# 3C PL1 – 324 Cherry Street

Schematic Design 2

April 22<sup>nd</sup>, 2020

Review Stage: Schematic Design 2

# Revised Roof Design · Plan

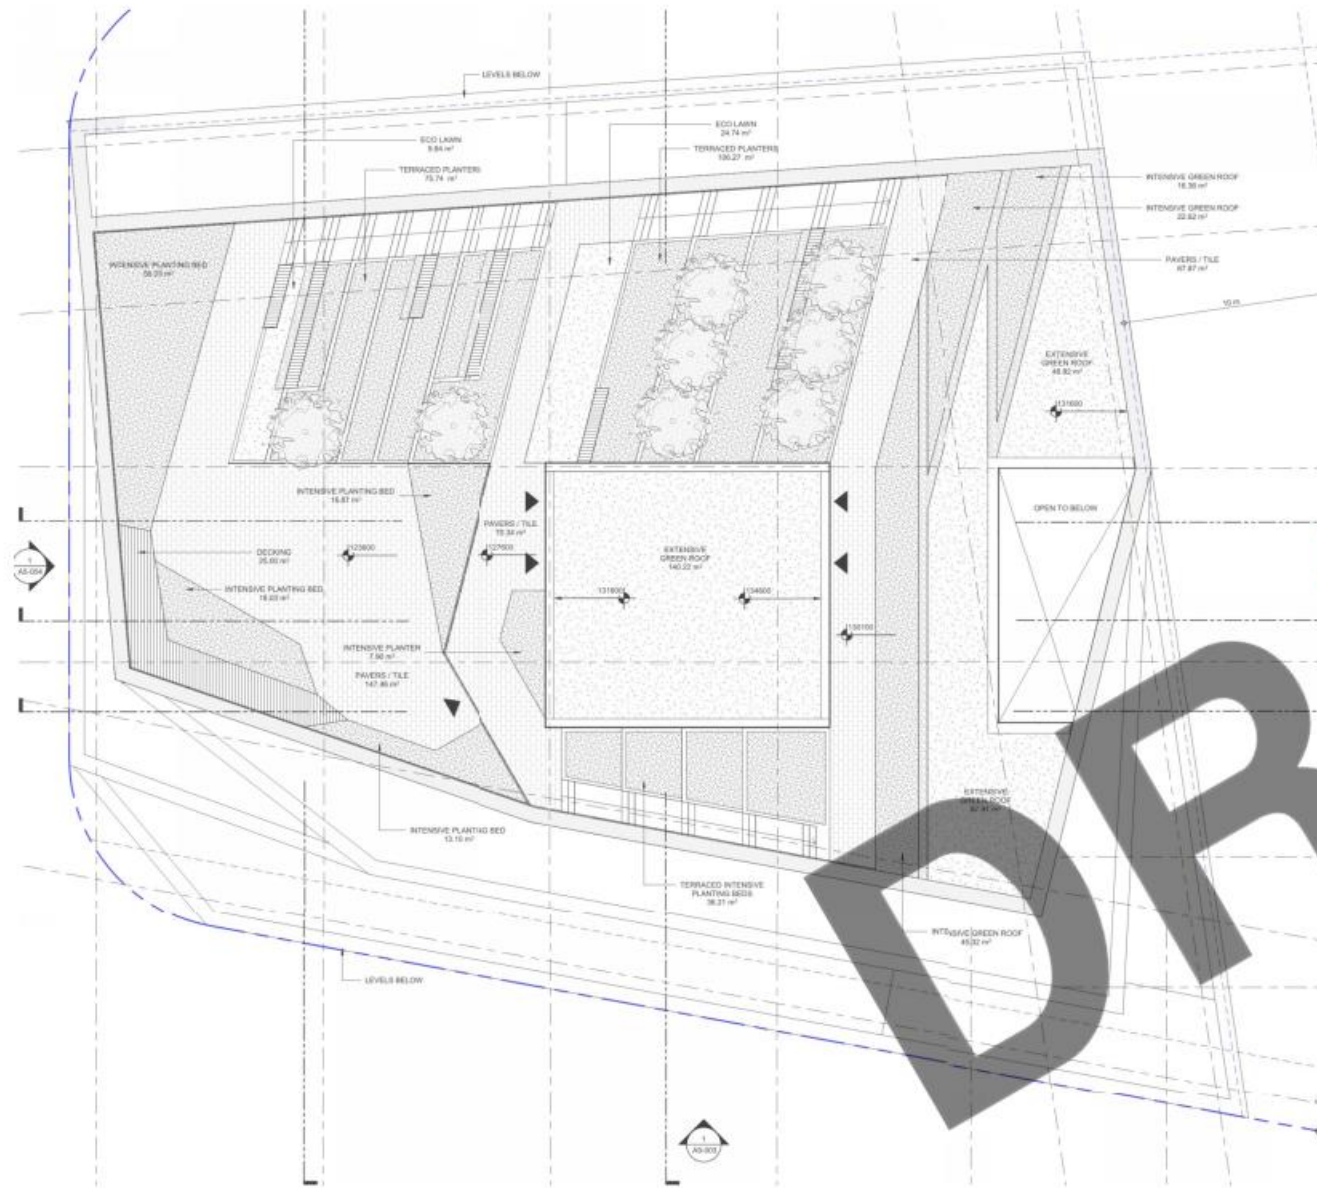
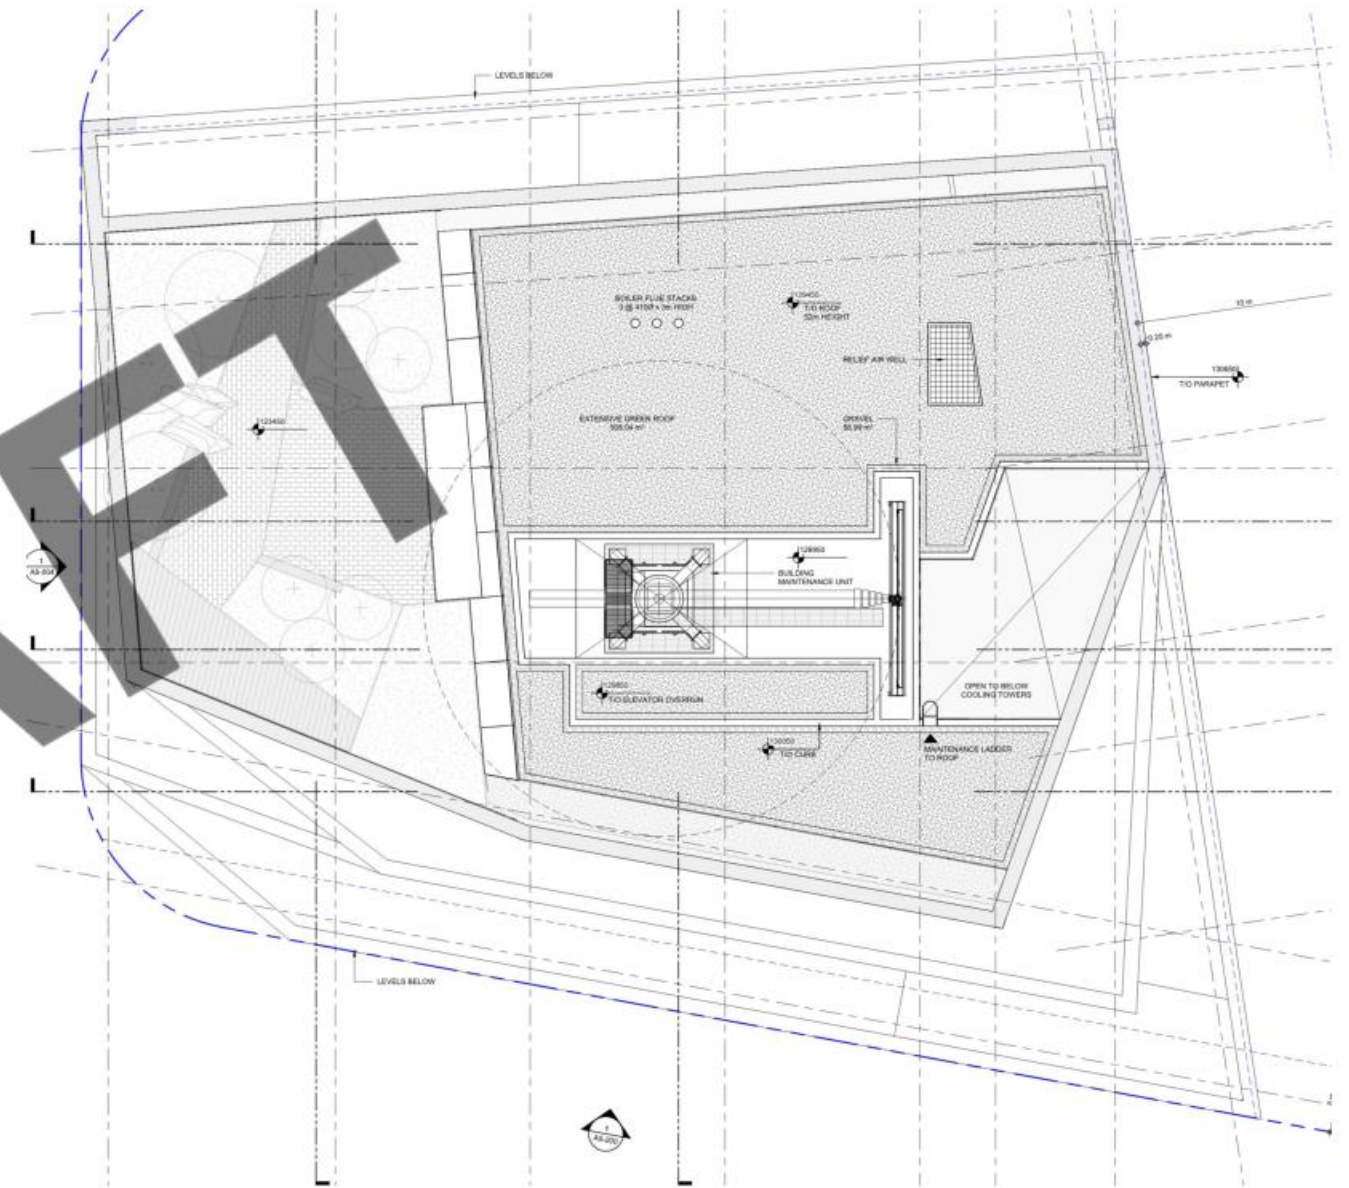
Building Height Update  
From SPA Feedback

\*Mechanical was reduced from 11m to 6m

# Landscape | Overall Design Update

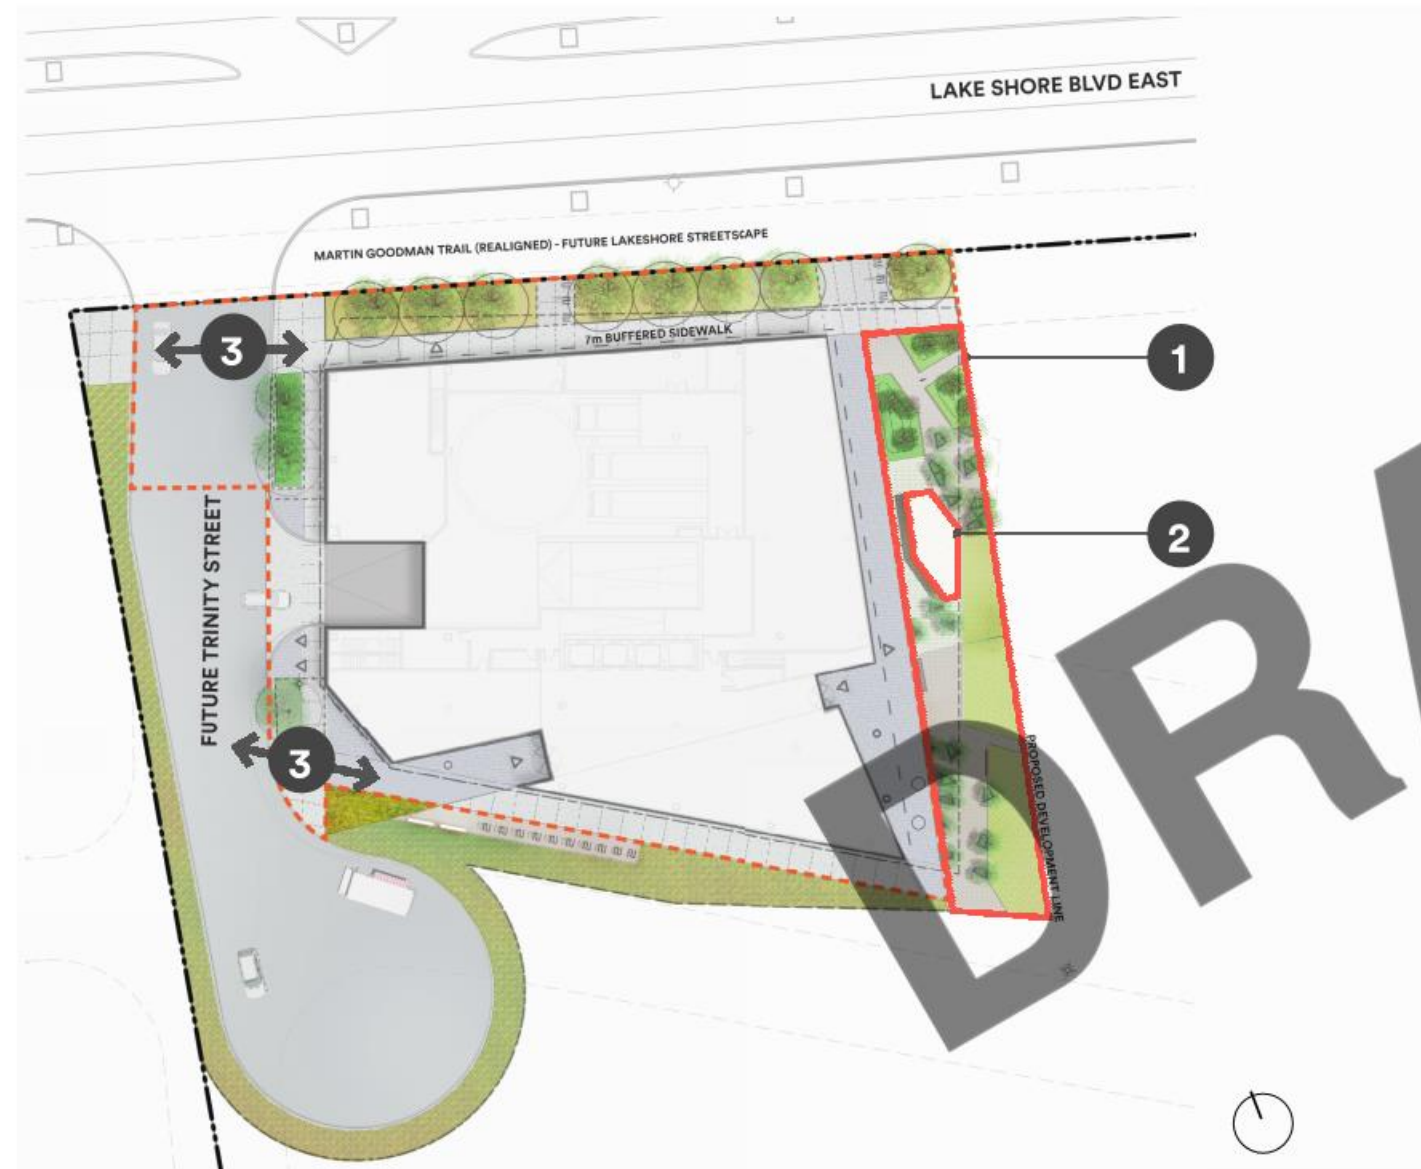
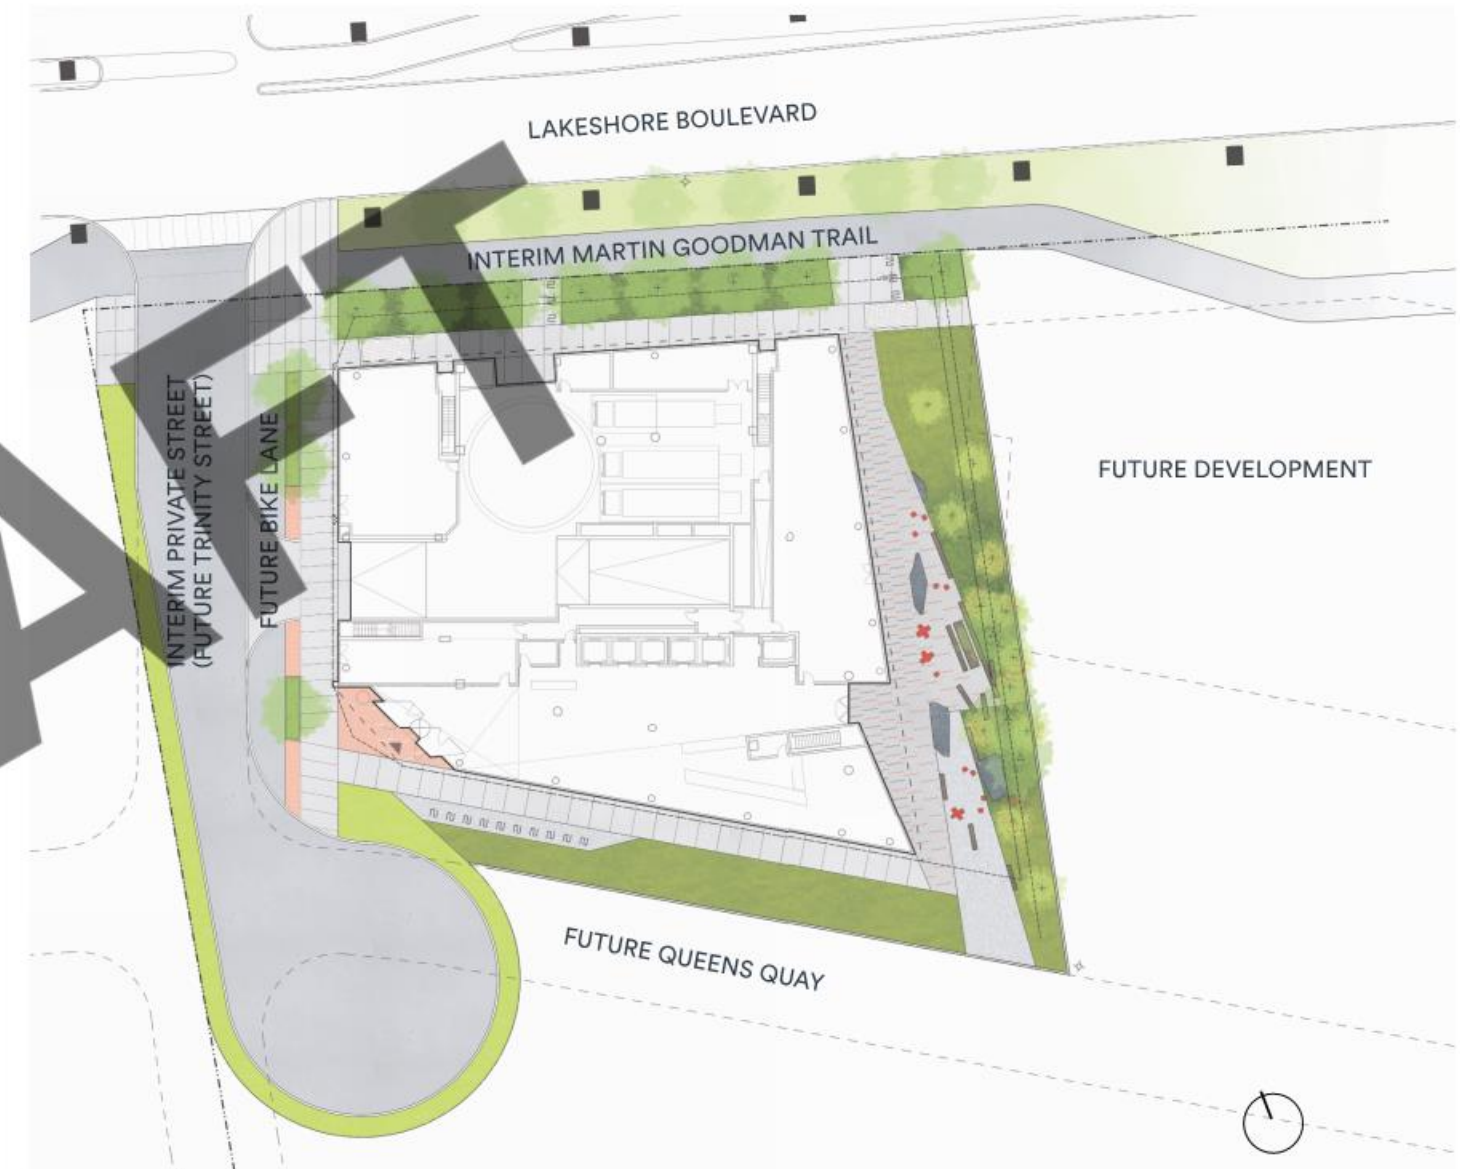
1. Scattered, consider a more focused single strategy
2. Not supportive of movable elements
3. Consider relationship between present + future development

1. Design altered to become more cohesive with the building and future build-out, and the concept of "refined --> raw"
2. Movable components eliminated and limited to tables and chairs
3. Leverage the temporary landscape for re-use throughout the phased development of the 3C site

# Landscape | Temporary vs Permanent

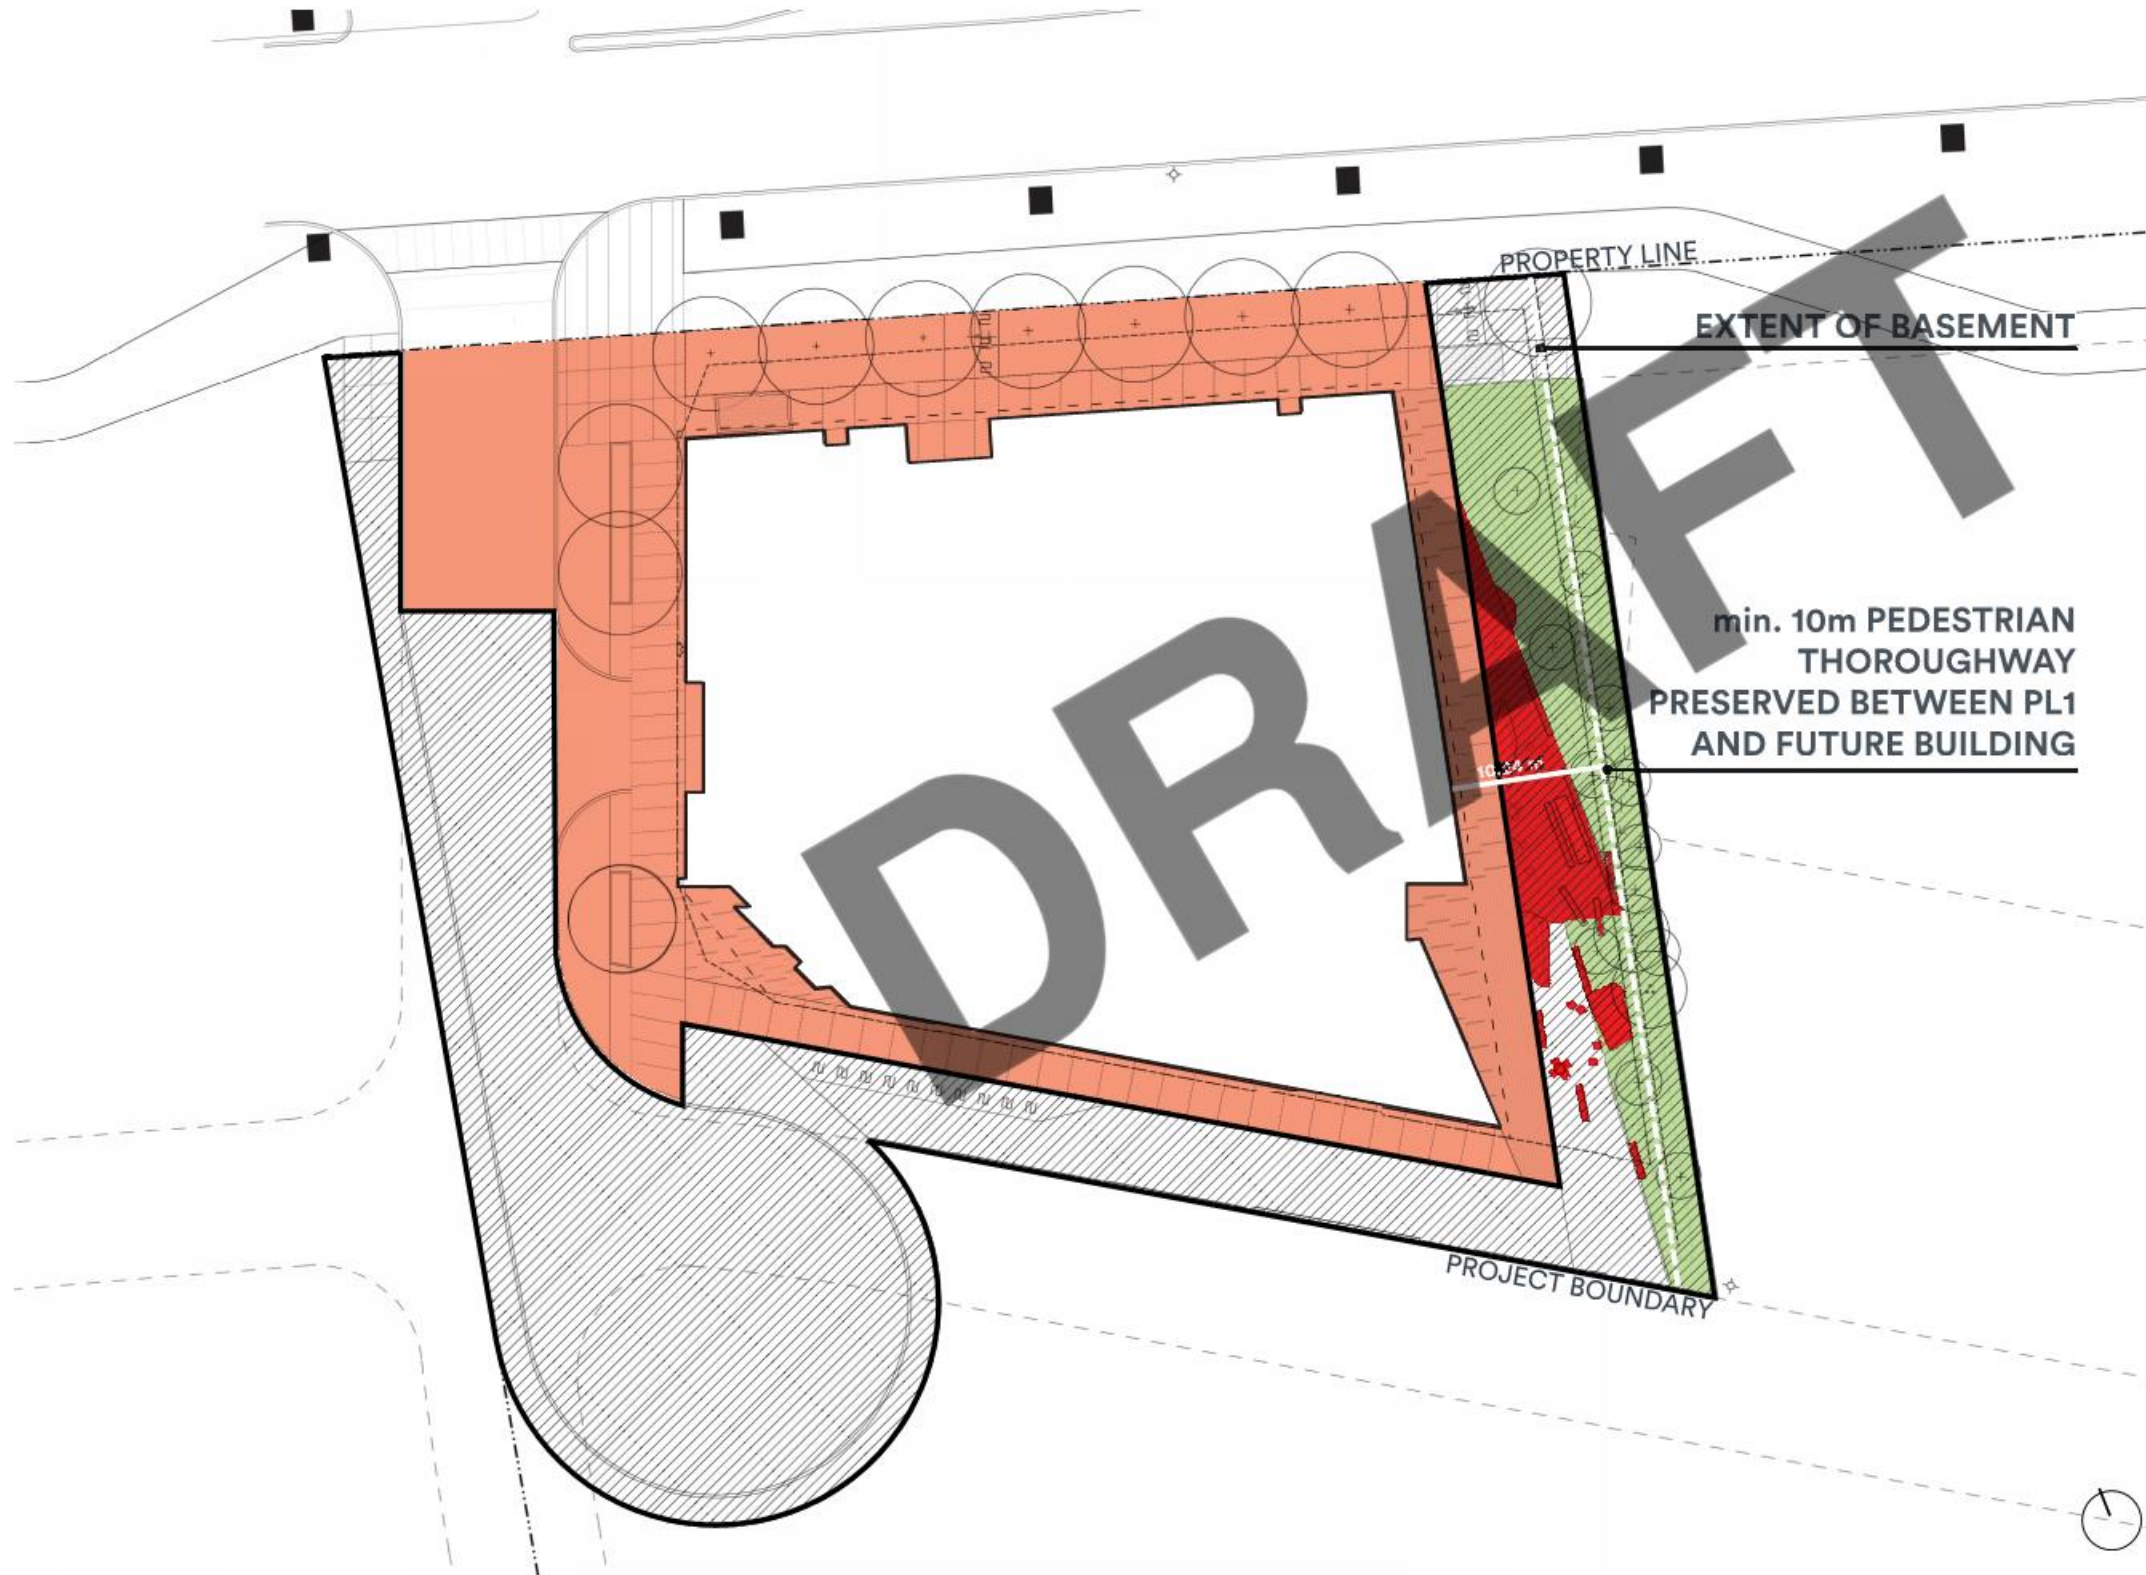
2. Consider delivering the plaza POP space as part of the Phase 1 development to provide additional outdoor amenity for tenants on day one.

**Response:** It is not possible to provide the entire plaza area with the initial phase due to the construction phasing of our underground garage and the impact on the balance of the future plaza area. Instead, we have incorporated strategies to deliver an interim plaza that can evolve into permanent plaza, formally and materially.
